EXPEDITED SETTLEMENT AGREEMENT

Number: ES-091014-1

Re: Facility Inspection / **Compliance Advisory**
Steamboat Ski & Resort Corp — Base Area Regrading Project
CDPS Permit No. COR03 C126
Routt County

Stormwater Inspection Report

Photograph 2—NW corner of site. Looking ESE at upgradient disturbance.

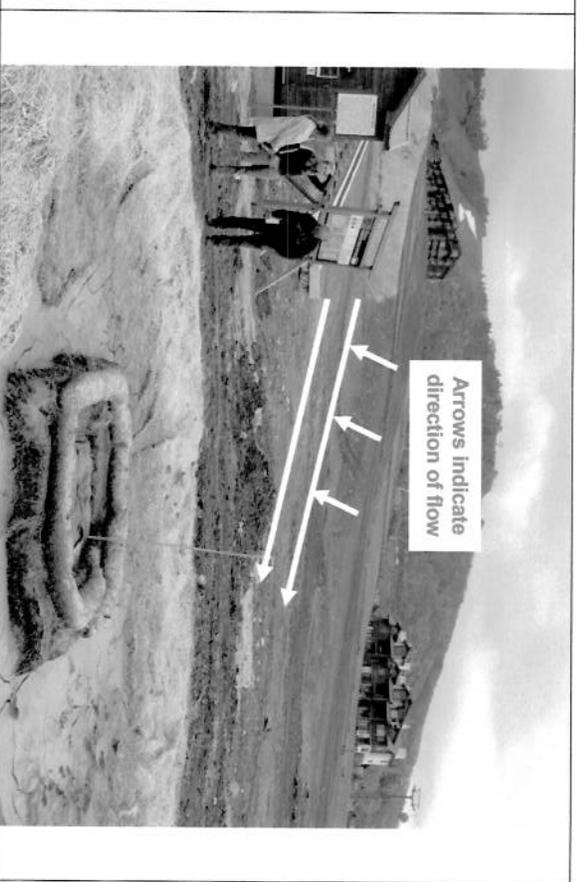
- b. No BMPS were implemented along the disturbed slopes located: i) at the northwest portion of the site, upgradient of the inlet adjacent to the Christy 6 sediment pond (see attached photograph 2) and, ii) at the western portion of the site, upgradient of the inlet located south of the Christy 6 sediment pond (see attached photograph 3). BMPs were not installed to control sheet flow and sediment transport down the disturbed slope toward these inlets. While inlet protection was observed for the drop inlets at the base of the disturbed slope (Dandy Bag, straw bale protection), this BMP is intended to be used as a polishing measure, not as a primary sediment trapping device. Upgradient erosion and sediment control BMPs must be implemented to prevent the discharge of sediment from this disturbed slope area.

8. It was noted during the inspection that BMPs were installed incorrectly and required maintenance at the inlet structures to Burgess Creek (State waters) located at the base of the ski slope (see attached photographs 2 and 3). Specifically, the straw wattle BMPs implemented on top of the straw bale BMPs were not entrenched, and are intended to be implemented on the ground so that an appropriate seal can be established. Furthermore, significant sediment was noted both adjacent to the straw bales inlet protection (photograph 2), and inside the inlet protection (photograph 3). As a result, there was a potential for discharge of sediment to Burgess Creek (State waters). Adequate BMPs must be implemented and maintained to prevent discharge of sediment from to the inlet structures to Burgess Creek.

Photograph 4—SW portion of site. Looking W at downgradient disturbance.

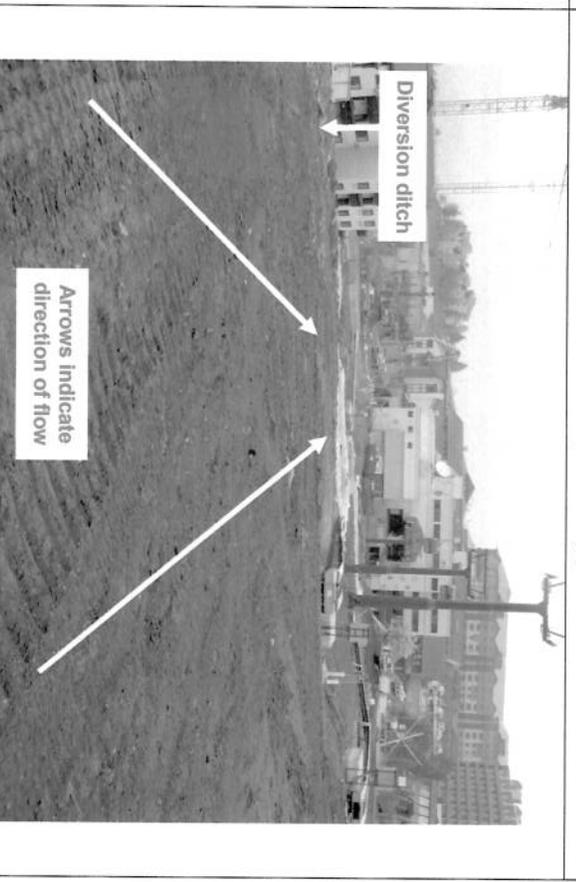
- c. Inadequate BMPs were implemented along the disturbed slope located at the southwest portion of the site, adjacent to the south perimeter diversion ditch (see attached photograph 4). The surface roughening BMP implemented on the disturbed slope is inadequate to handle the upslope drainage area as the sole BMP for this area. Adequate BMPs must be implemented to prevent discharge of sediment from this disturbed slope area.

Photograph 5—SE edge of site. Looking NE at upgradient disturbance.

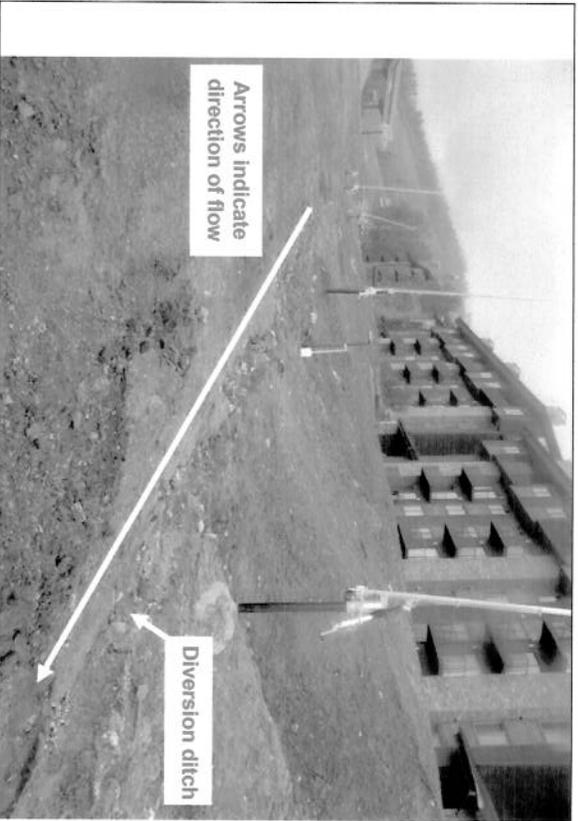
- i) at the SE portion of the site, midway up the slope (south perimeter ditch) (see attached photograph 5),
- ii) at the NW corner of the site (interior ditch) (see attached photographs 12, 13 and 15),
- iii) at the SW portion of the site (interior ditch) (see attached photograph 14) and,
- vi) at the SW corner of the site (south perimeter) (see attached photograph 24).

- d. No BMPS were implemented along the disturbed slopes located: i) at the southeast portion of the site, south of the south perimeter diversion ditch (see attached photograph 5), ii) at the far eastern portion of the site (see attached photograph 6) and, iii) at the far north-eastern portion of the site, downslope and adjacent to the ski lift (see attached photograph 7). BMPs were not installed to control sheet flow and sediment transport down the disturbed slopes, and the slopes themselves were not stabilized. Adequate BMPs must be implemented to prevent discharge of sediment from these disturbed slope areas.

Photograph 17—NW corner of site. Looking SE at diversion ditch.

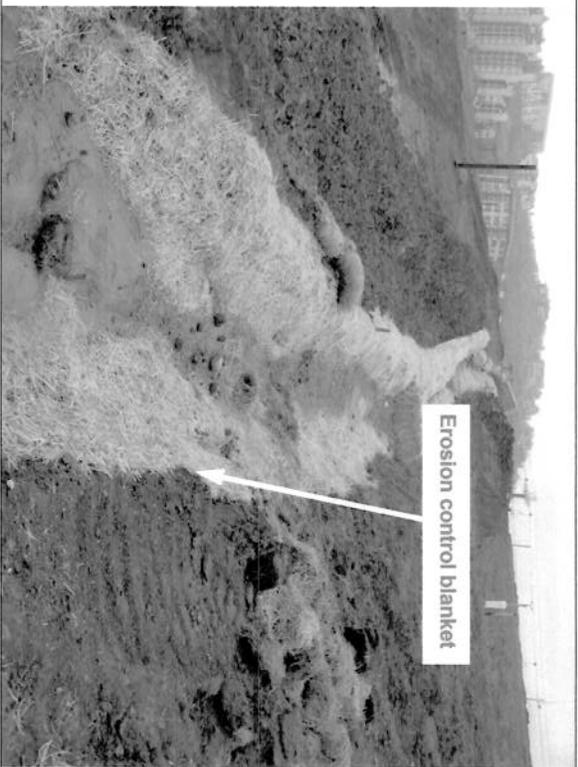
- d. The erosion control blanket BMPs located in: i) the diversion ditch located at the NW corner of the site, leading to the inlet adjacent to the Christy 6 sediment pond (see attached photograph 17), and ii) in the western-most water bar draining to the south perimeter diversion ditch in the SW corner of site (see attached photograph 18), were not installed according to the installation detail provided in the SWMP. The edges of the blanket were not secured (entrenched) to prevent undercutting. Adequate BMPs must be implemented and installed correctly to prevent erosion and discharge of sediment from the diversion ditches across the site.
